## CITY OF PARKER AGENDA ITEM SUMMARY

DEPARTMENT MAKING REQUEST/NAME OF PRESENTER:  <b>Nelson</b>	2. MEETING DATE:  <b>1/20/26</b>
3. PURPOSE:  <b>5233 Melissa Dr – Parcel 24992-564-000 Single Family Home Addition</b>	
4. IS THIS ITEM BUDGETED (IF APPLICABLE)  YES <input type="checkbox"/> NO <input type="checkbox"/> N/A <input checked="" type="checkbox"/>	
 <b>Approval of Home Addition</b>

## PLANNING REVIEW COMMENTS

Review Date: OCTOBER 28, 2025  
Owner Name: JEFFREY AND NAOMI NELSON  
Contractor Name: L&M CONSTRUCTION AND DEVELOPMENT, LLC  
Permit No.: N/A  
Project Name: MINOR DEVELOPMENT SINGLE-FAMILY HOME/ADDITION  
PROPOSED ADDITION TO EXISTING SINGLE-FAMILY RESIDENCE  
5233 MELISSA DRIVE, PARKER, FLORIDA  
PARCEL NO. 24992-564-000  
SUBMITTAL NO. 2 REVIEW

**ARCHITECTURAL FLOOR PLAN**

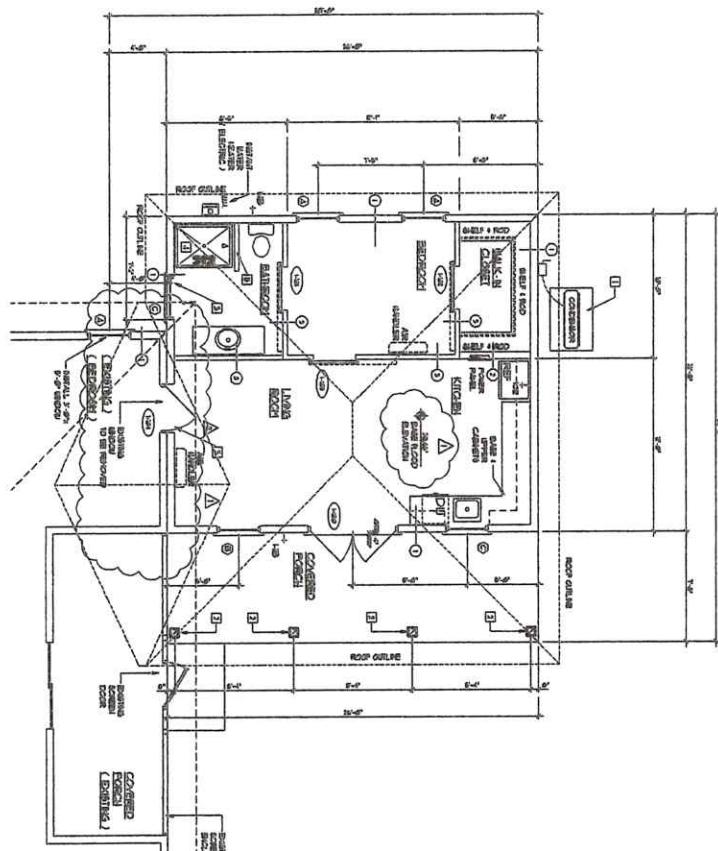
Additional approval is required by the City to determine if this is considered an addition or if it is considered an accessory dwelling unit.

This addition will be connected to the same building footprint as the existing dwelling unit through an outside concrete breezeway and roofing. However, it will have its own entrances, and will not share a common wall, which could potentially be considered an Accessory Dwelling Unit (ADUs). ADUs are not allowed within the City of Parker per the Parker Land Development Regulations definition.

Applicant has revised Floor Plan to indicate an addition, which is connected to the existing dwelling unit through a mutual storage wall. However, the Addition will have its own porch and entrances, kitchen, and living room. **Though it is considered an addition to the existing dwelling unit, it can also be considered an attached-ADU because it does contain a separate living area. Per Article 5-4.2 – Accessory Dwelling Units, Item #2 states: No variations, adjustments, or waivers to the requirements of the Land Development Regulations shall be allowed in order to accommodate an accessory dwelling unit. Additional approval is required by the City to determine if this is considered an addition or if it is considered an accessory dwelling unit.**

The house addition has been modified to connect to the existing house structure – Refer to Sheet A1.01

The proposed addition to the existing residential structure does not constitute an Accessory Dwelling Unit per the City of Parker Land Development Regulations dated November 1, 2022.

- The proposed addition is physically connected to the existing residence on two walls and under one contiguous roof.
- This addition meets the City of Parker definition of "An Accessory Use" structure which is permitted under the Land Development Regulations.
- The amenities provided in the proposed addition including a separate living area are permissible under the Land Development Regulations Article 5 DEVELOPMENT STANDARDS Section 5-4.4 sub-section 1 "PURPOSE Residential development projects may provide amenities for the exclusive use of
